PIC18F85J90 Family Silicon Errata and Data Sheet Clarification

The PIC18F85J90 family devices that you have received conform functionally to the current Device Data Sheet (DS39770C), except for the anomalies described in this document.

Data Sheet Clarifications

The following typographic corrections and clarifications are to be noted for the latest version of the device data sheet (DS39770C):

FIGURE 2-3 FREQUENCY vs. ESR PERFORMANCE FOR SUGGESTED VCAP

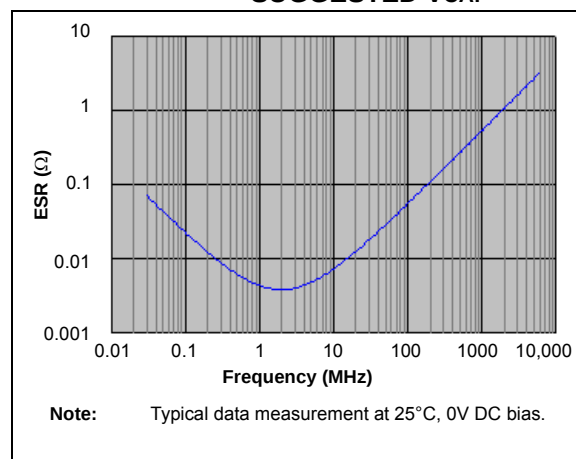
Section 2.4 “Voltage Regulator Pins (ENVREG and VCAP/VDDCORE)” has been replaced with a new and more detailed section. The entire text follows:

When the regulator is enabled, a low-ESR ($< 5\Omega$) capacitor is required on the VCAP/VDDCORE pin to stabilize the voltage regulator output voltage. The VCAP/VDDCORE pin must not be connected to VDD and must use a capacitor of 10 μF connected to ground. The type can be ceramic or tantalum. Suitable examples of capacitors are shown in [Table 2-1](#). Capacitors with equivalent specification can be used.

Designers may use [Figure 2-3](#) to evaluate ESR equivalence of candidate devices.

FIGURE 2-4 DC BIAS VOLTAGE vs. CAPACITANCE CHARACTERISTICS

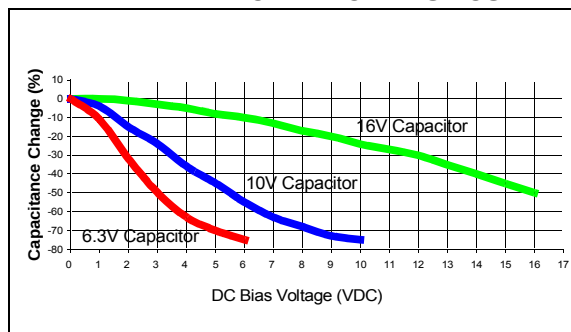
In addition to temperature tolerance, the effective capacitance of large value ceramic capacitors can vary substantially, based on the amount of DC voltage applied to the capacitor. This effect can be very significant, but is often overlooked or is not always documented.

A typical DC bias voltage vs. capacitance graph for X7R type and Y5V type capacitors is shown in Figure 2-4.

When selecting a ceramic capacitor to be used with the VDDCORE voltage regulator, it is suggested to select a high-voltage rating, so that the operating voltage is a small percentage of the maximum rated capacitor voltage. For example, choose a ceramic capacitor rated at 16V for the 2.5V VDDCORE voltage. Suggested capacitors are shown in Table 2-1.
